MIL-C-17587B(SH)
AMENDMENT 4
2 August 1994
SUPERSEDING
AMENDMENT 3
4 March 1994

MILITARY SPECIFICATION

CIRCUIT BREAKERS, LOW VOLTAGE, ELECTRIC POWER, AIR,
OPEN FRAME, REMOVABLE CONSTRUCTION

FIGURE 1. Outline and mounting dimensions for circuit breaker type ACB-900R.

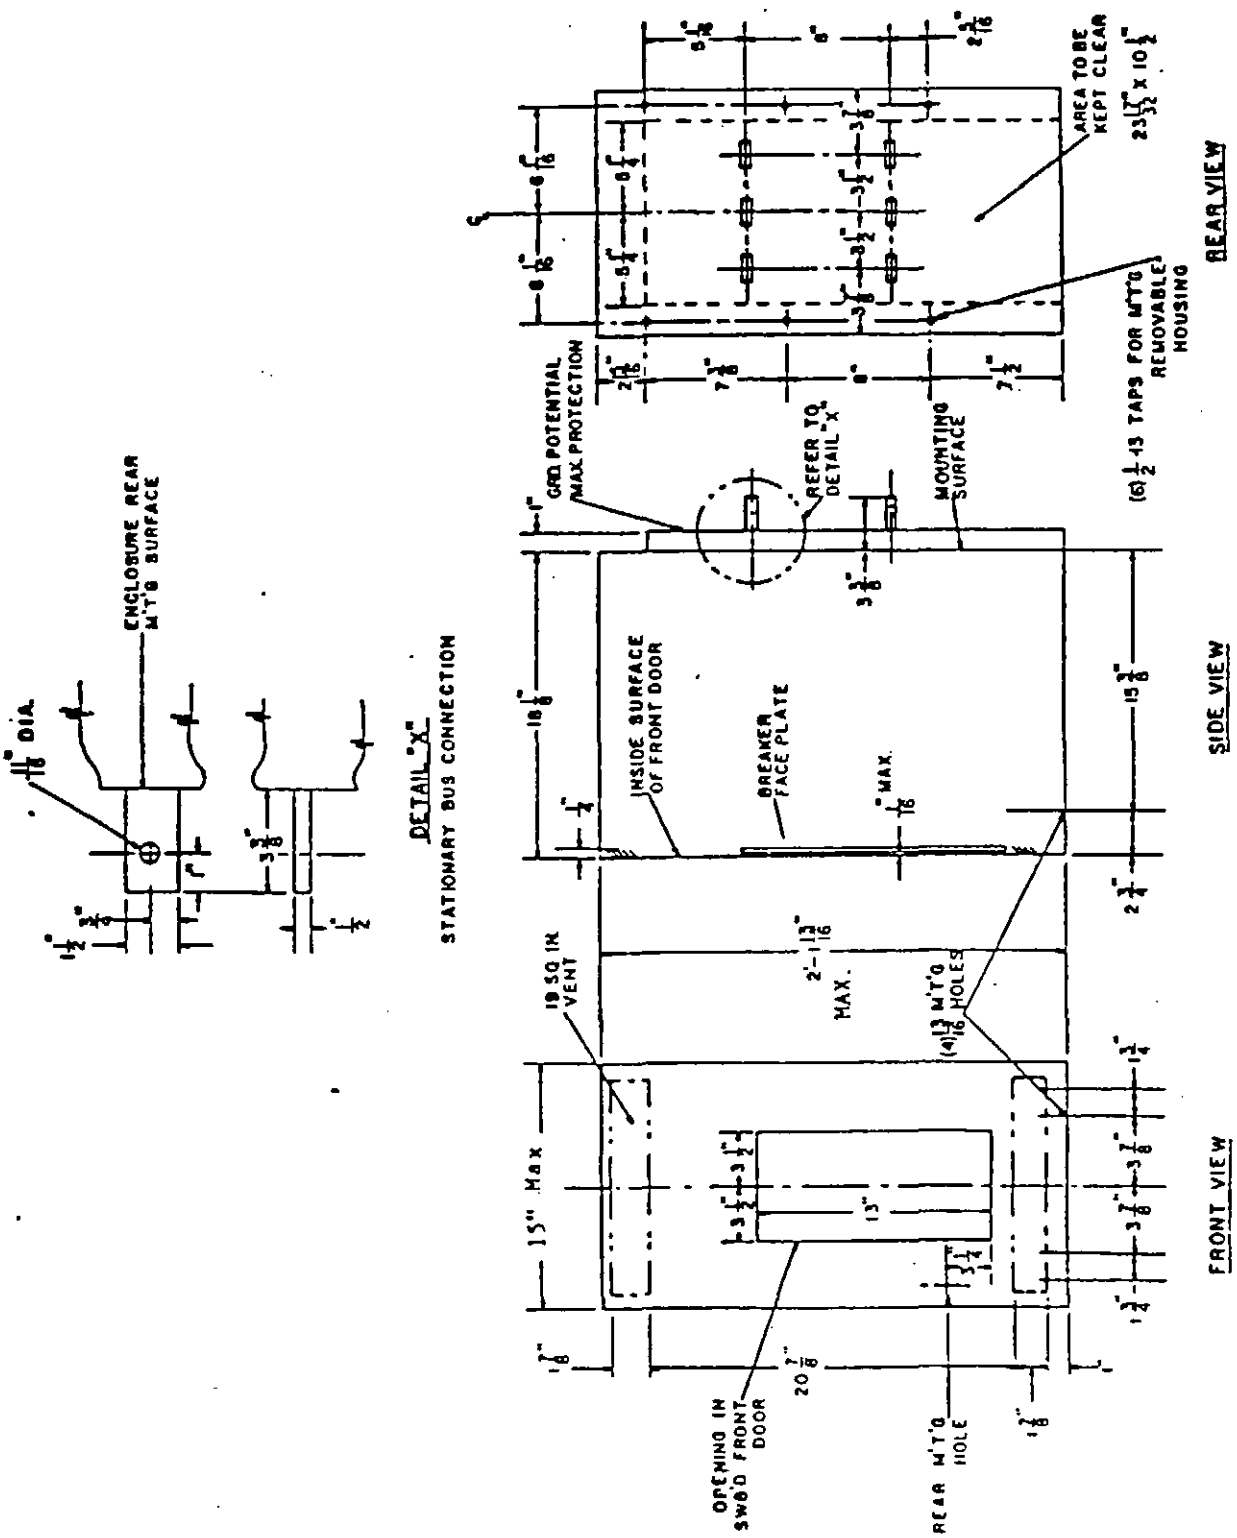
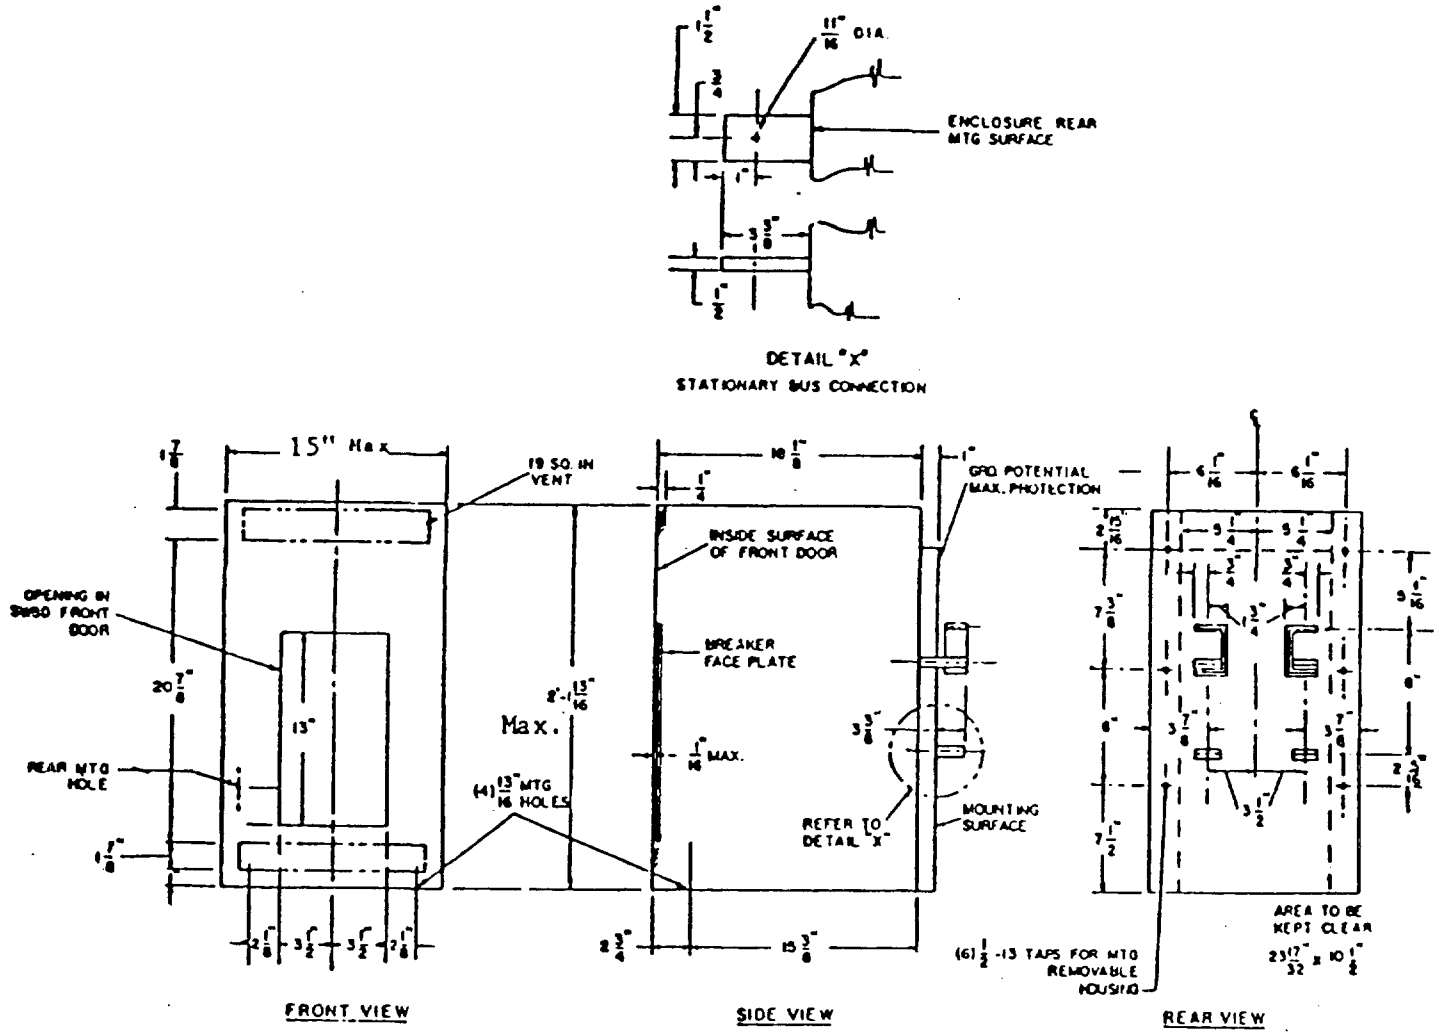
Figure 1: Delete and substitute:

FIGURE 4. Outline and mounting dimensions for circuit breaker types ACB-1600HR, ACB-2000R, ACB-2000LR, ACB-2601R, and ACB-2801R.

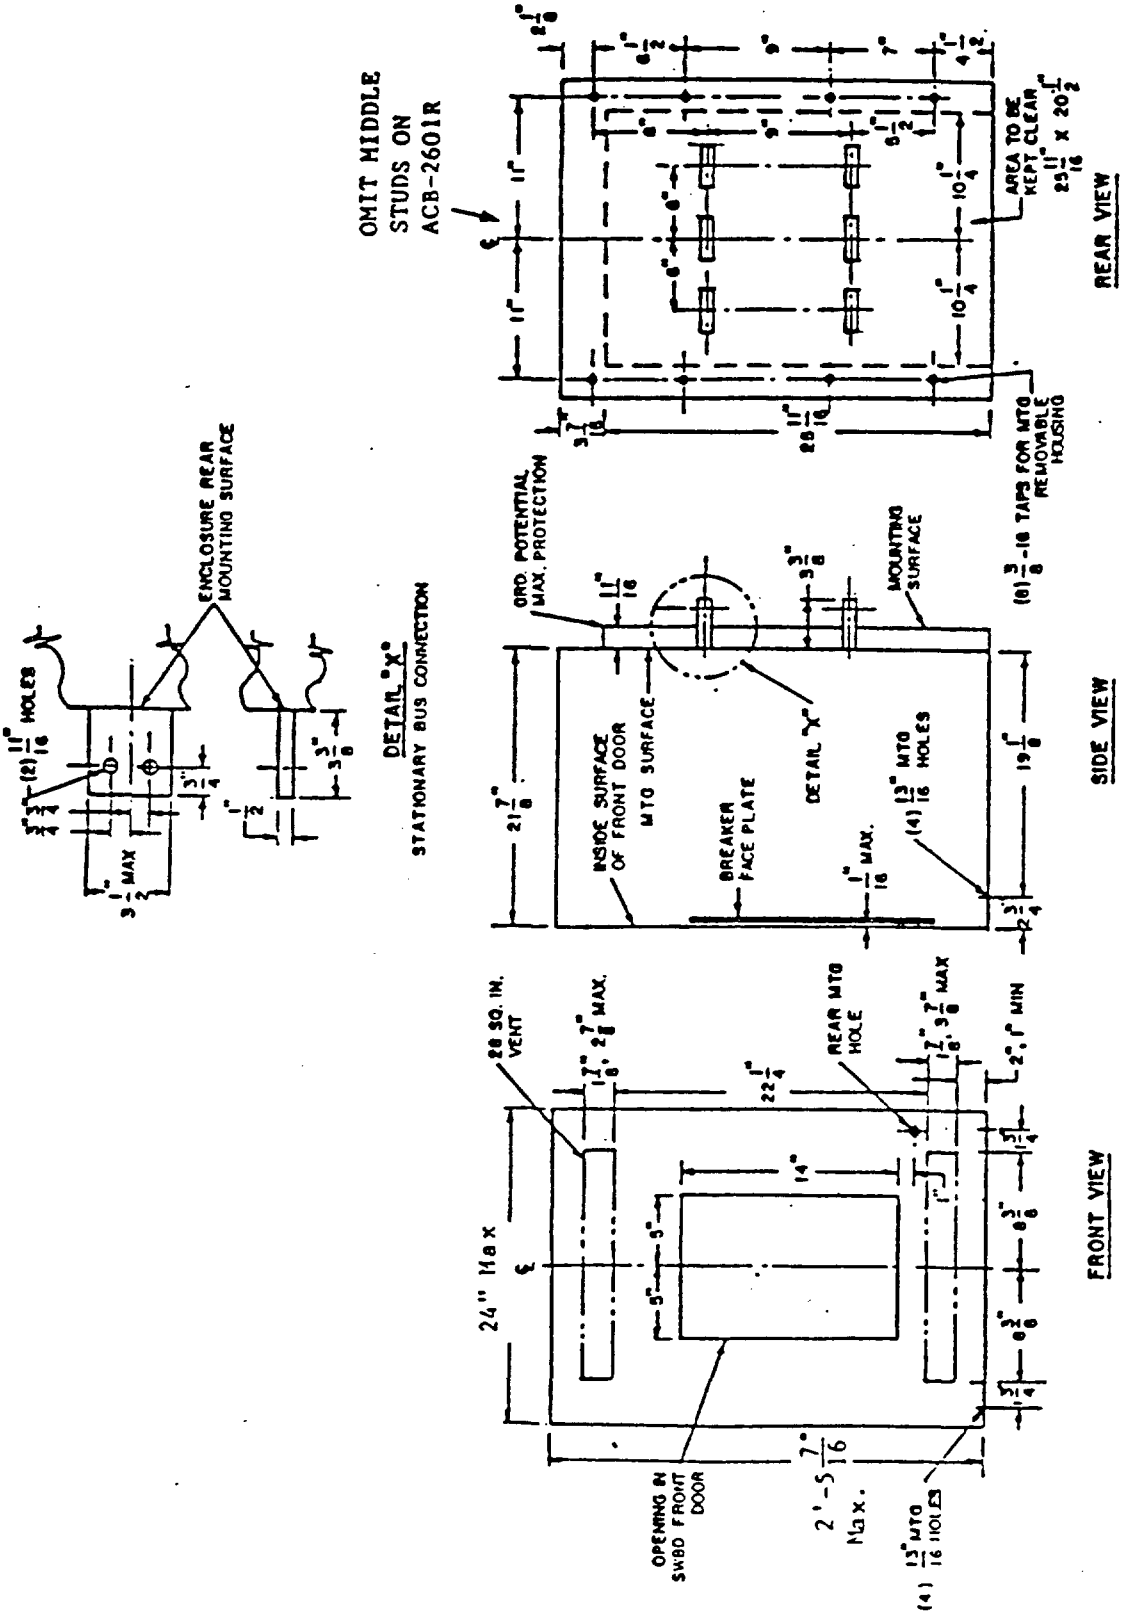
Figure 4: Delete and substitute:

FIGURE 5. Outline and mounting dimensions for circuit breaker type ACB-2002HR.

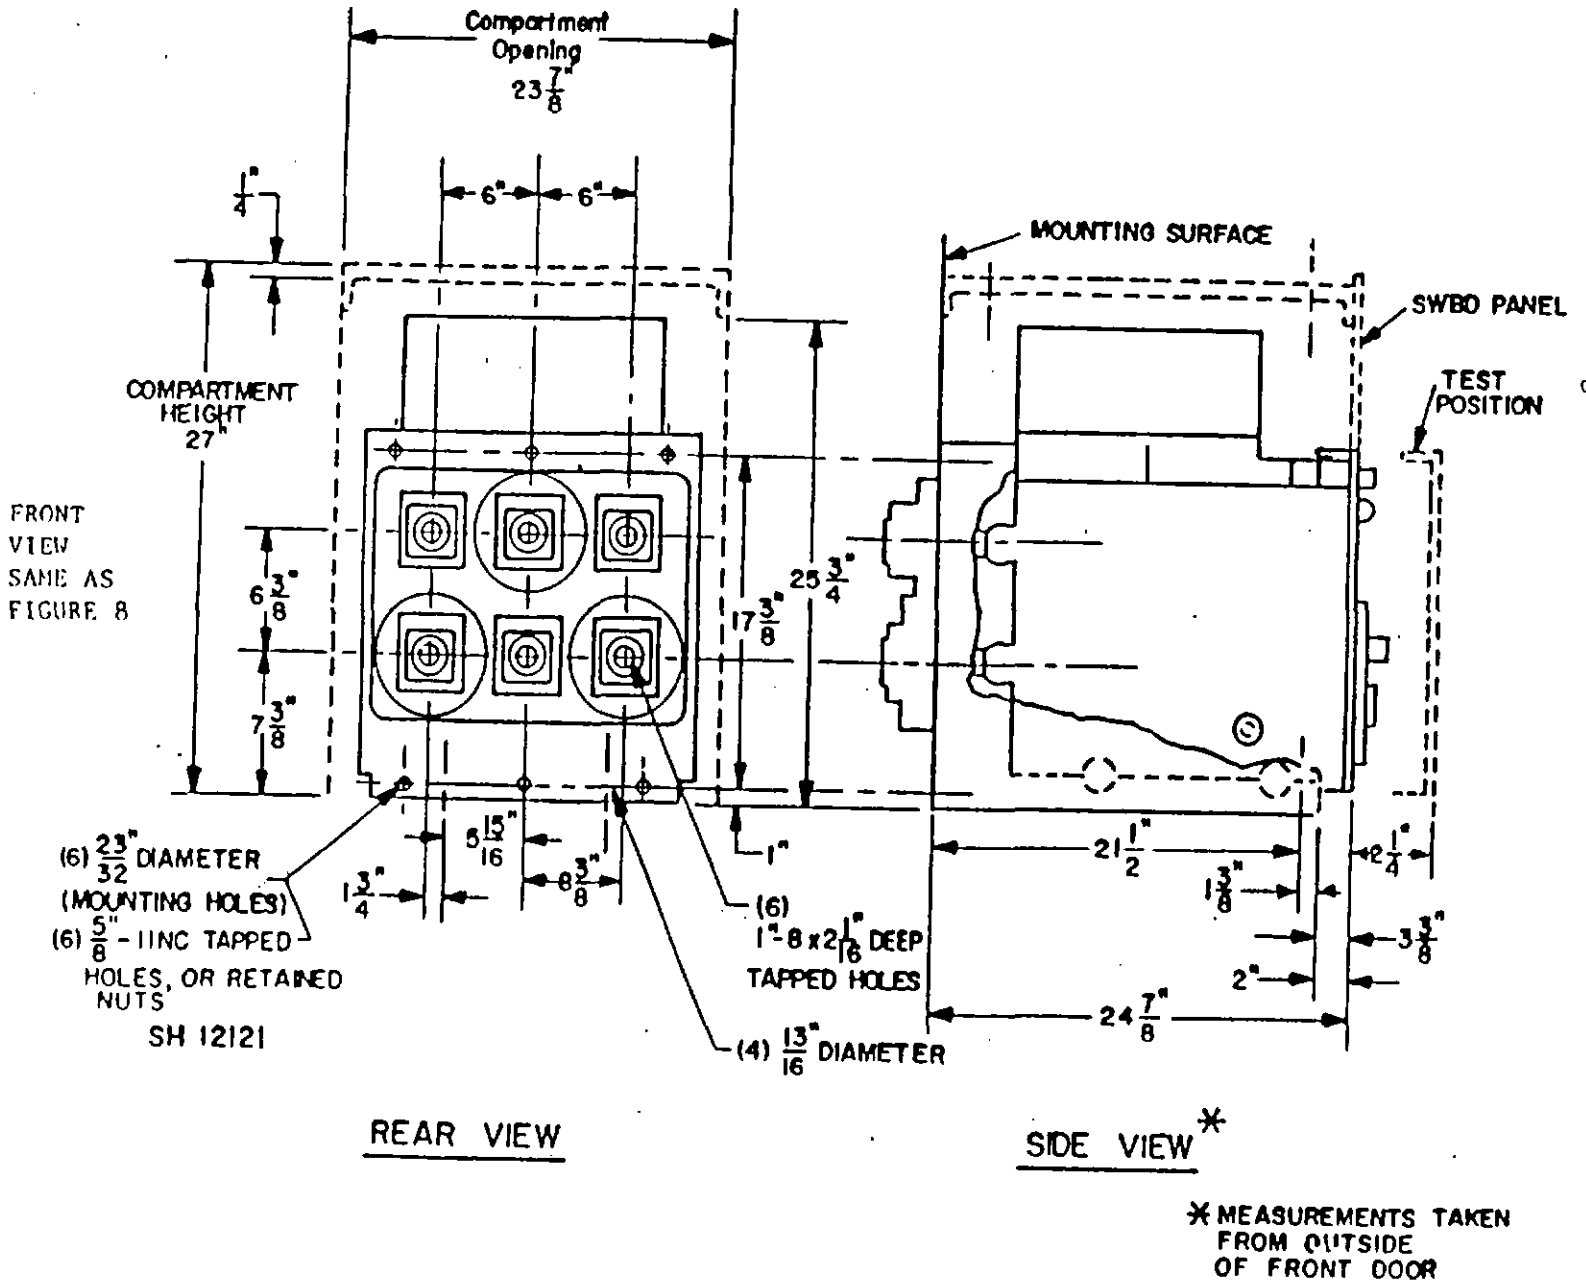
Figure 5: Delete and substitute:

FIGURE 7. Outline and mounting dimensions for circuit breaker types ACB-3200HR, ACB-4000HR and ACB-5001R.

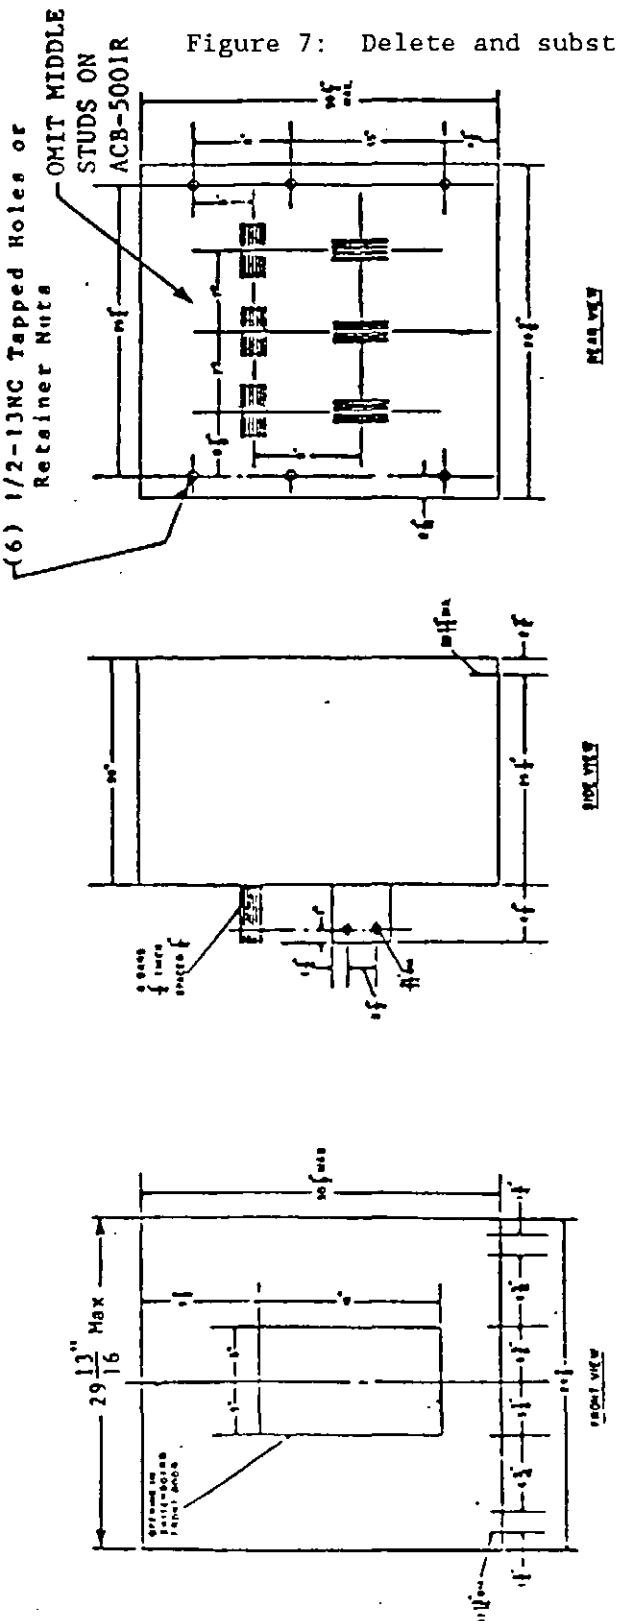
Figure 7: Delete and substitute:

FIGURE 8. Outline and mounting dimensions for circuit breaker type ACB-4001R.

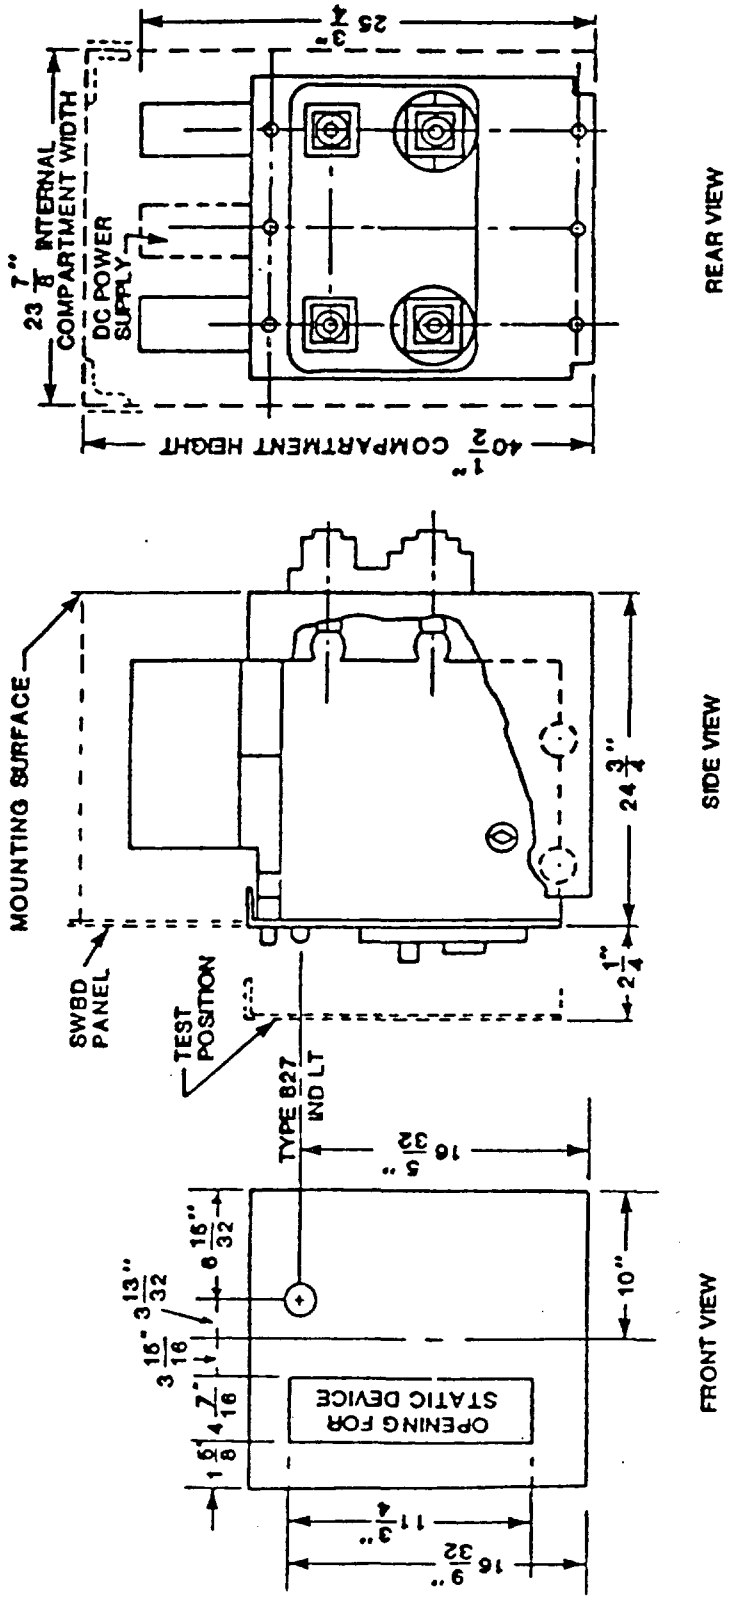
Figure 8: Delete and substitute:

FIGURE 9A. Outline and mounting dimensions for circuit breaker type ACB-1604LRC.

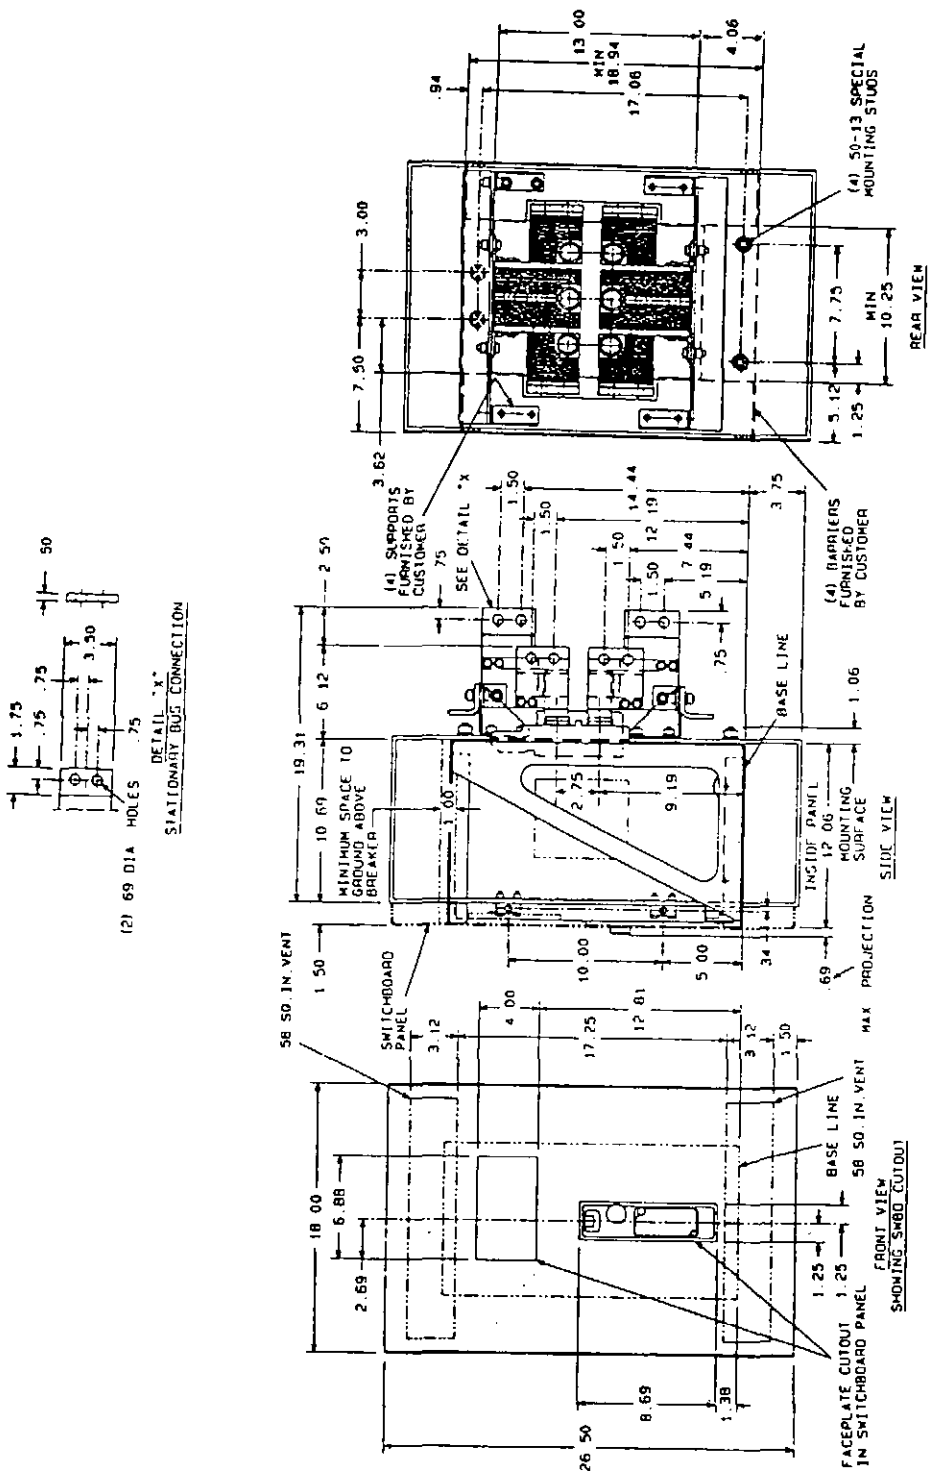
*Add new figure:
